Process Change Notification PCN 49-2020

The purpose of this PCN is to notify customer of the implementation of a new AC013 dispensing material (barrier gel) that is being used on the package of the TMF8801/TMF8701 products.

Figure 1. SEM images of the dispensing materials AB025 (current) and AC013 (new). Main difference is the sizes of the filler that could cause mechanical damage when product is subjected to high temperature solder reflow.

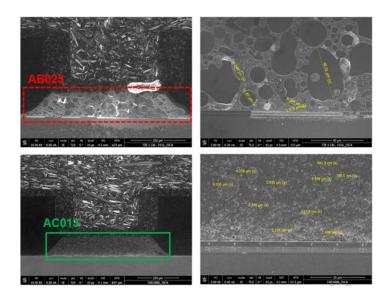
Subsequent experiments done by ams AG determined that failures might occur when the parts are subjected to high temperature reflow. Based on failure mechanism, the **current dispensing material (barrier gel) AB025** has fillers that can induced mechanical damages on the die surface when the product goes through solder reflow.

ams AG then investigated a potential improvement and found that the introduction of the **new dispensing material (barrier gel) AC013** will completely prevent the mechanical damage encountered by the current dispensing material.
